ADDENDUM No. 1

Menominee County ISD, Central Elementary Fire Alarm UPEA Project No. M385-04227 (FA)

This **ADDENDUM NO. 1**, issued on November 25, 2025, is to clarify, modify and/or change the original plans and specifications issued by U.P. Engineers & Architects, Inc., and is hereby made a part of the bidding documents.

E100

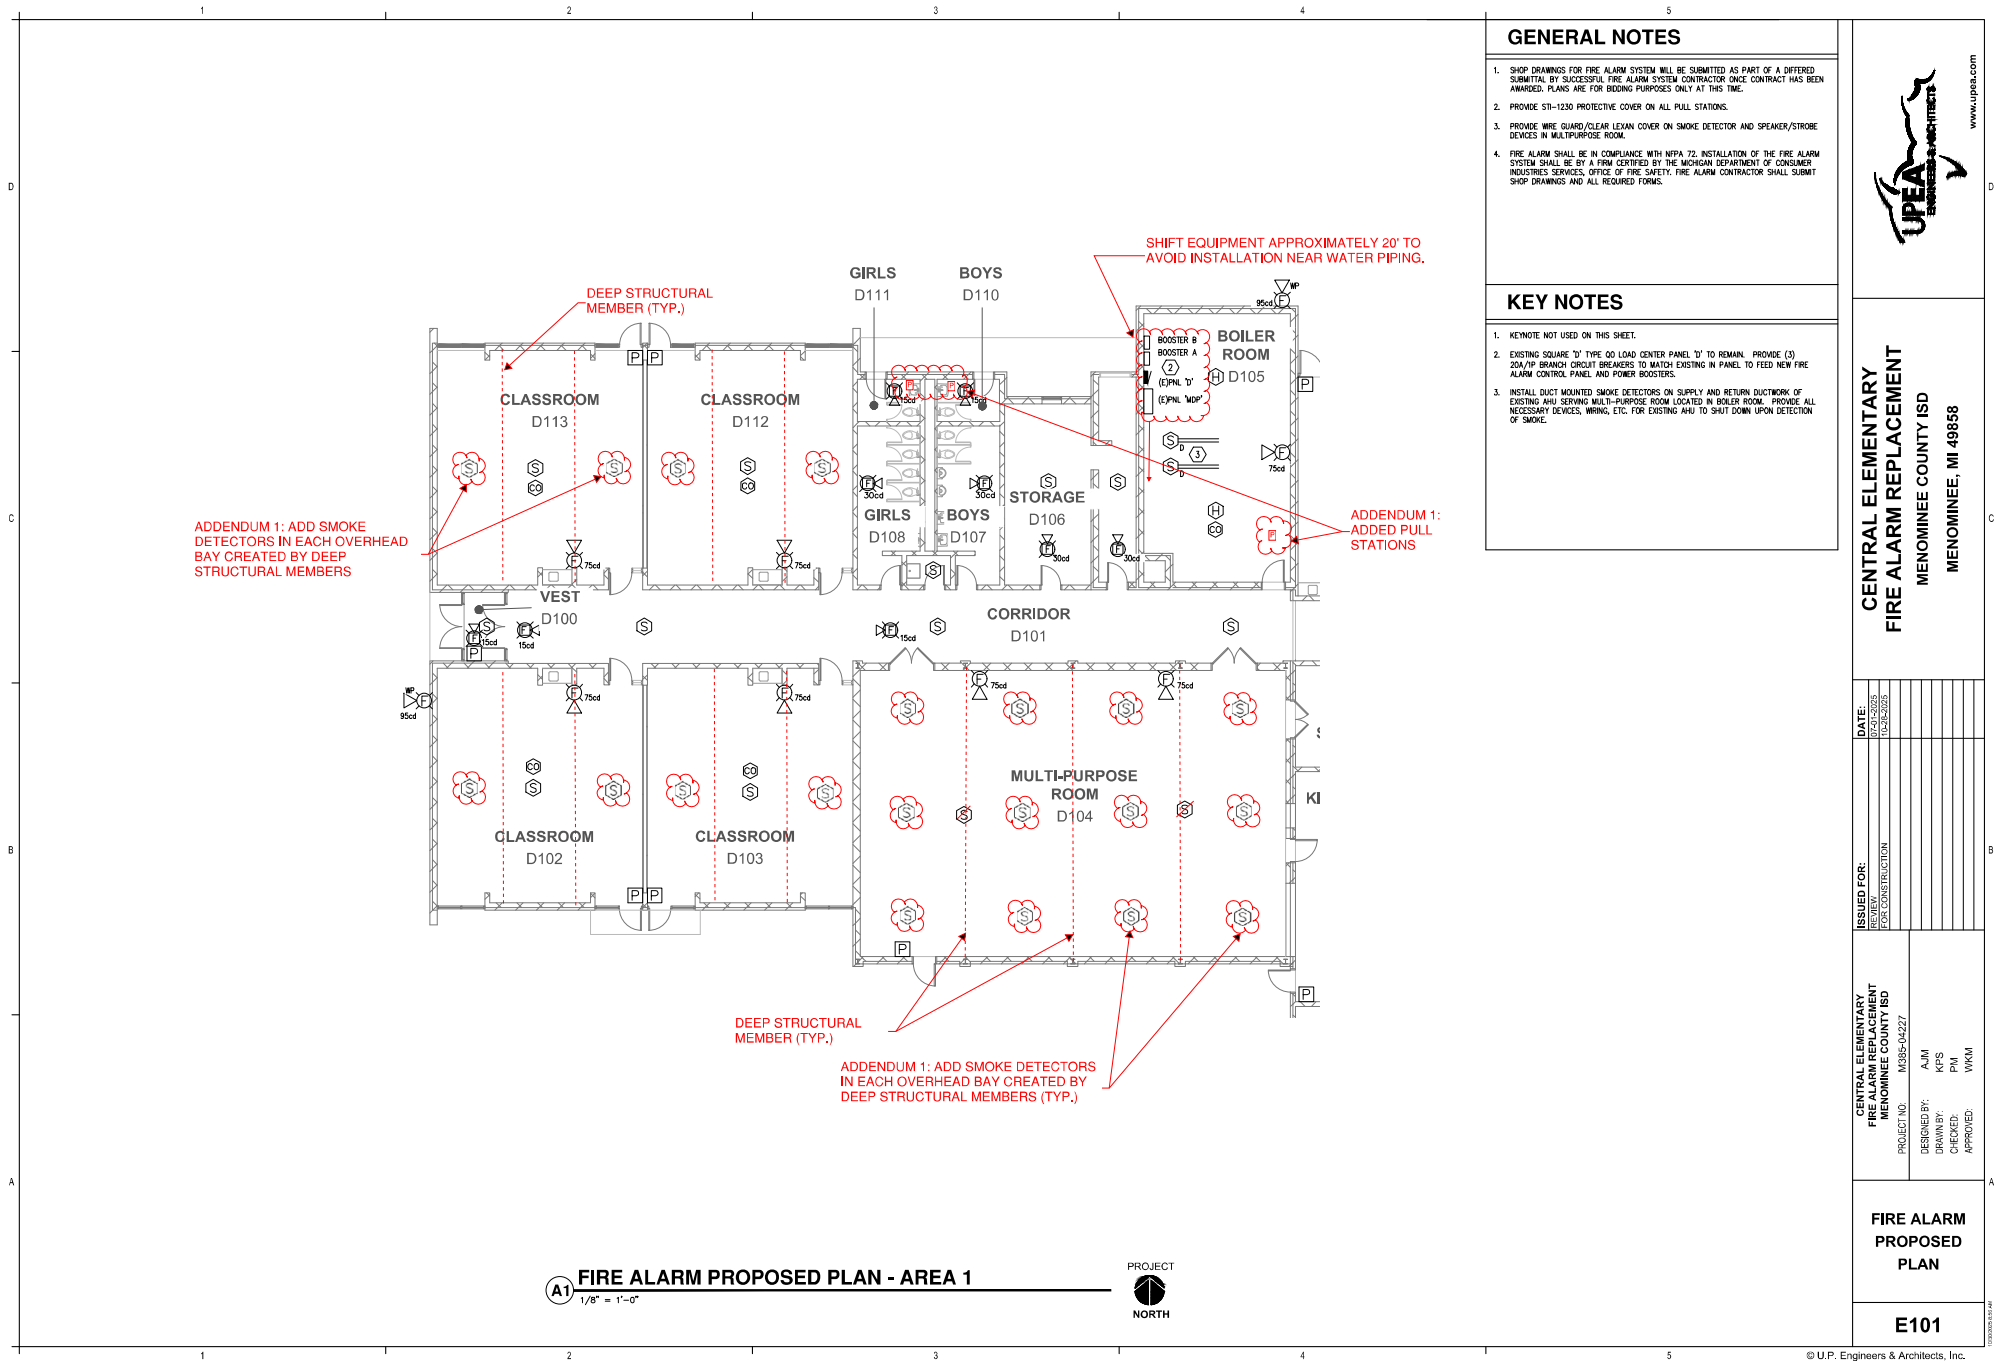
1. Pull Stations: E100, E101, E502 - Add pull station to exterior door of Boys D110 and Girls 111 and at bottom of stairs in Boiler Room D105. See attached revise plan.
2. Smoke Detectors: E100, E101, E103, and E502 – Additional smoke detectors added to rooms where deep structural members create overhead bays greater than 12" depth. See attached revised plan.
